P ~~63286~~ 535730

ON-SITE SEWAGE DISPOSAL SYSTEM TANK REPLACEMENT HOWARD COUNTY HEALTH DEPARTMENT BUREAU OF ENVIRONMENTAL HEALTH

ADDRESS: 12010 Triadelphia Road PROPERTY OWNER: Jack Lauderdale

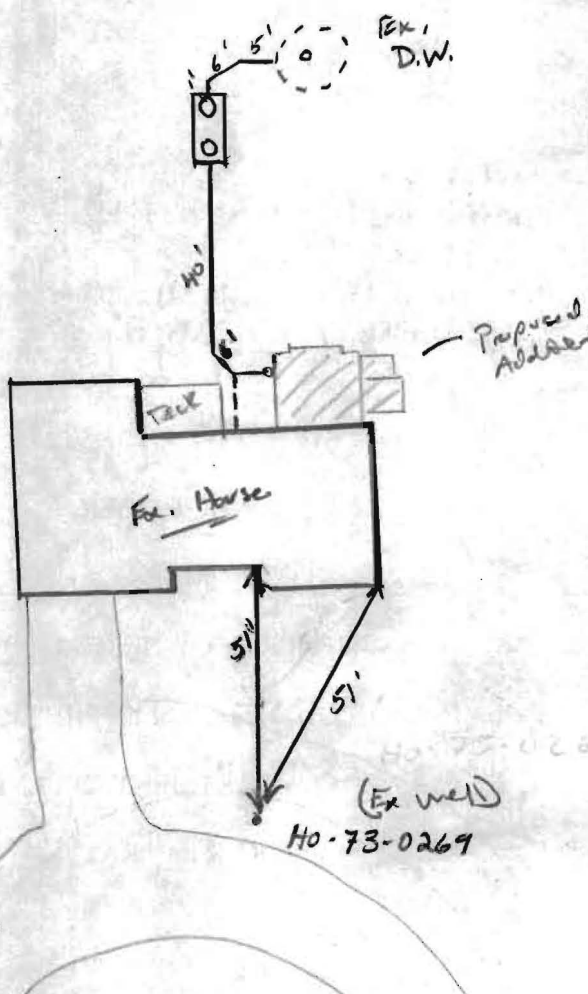
6/14/11 Spoke w/ contractor on phone. Told him it was ok to set back. Make sure addition is staked out and new tank location is at least 20' removed. Call when done is set (14)

6/27/11 New S.T installed. Baffles installed. Tied back in existing Day wall. 106 feet Add. Could not confirm setback from new addition as it was not staked. (14)
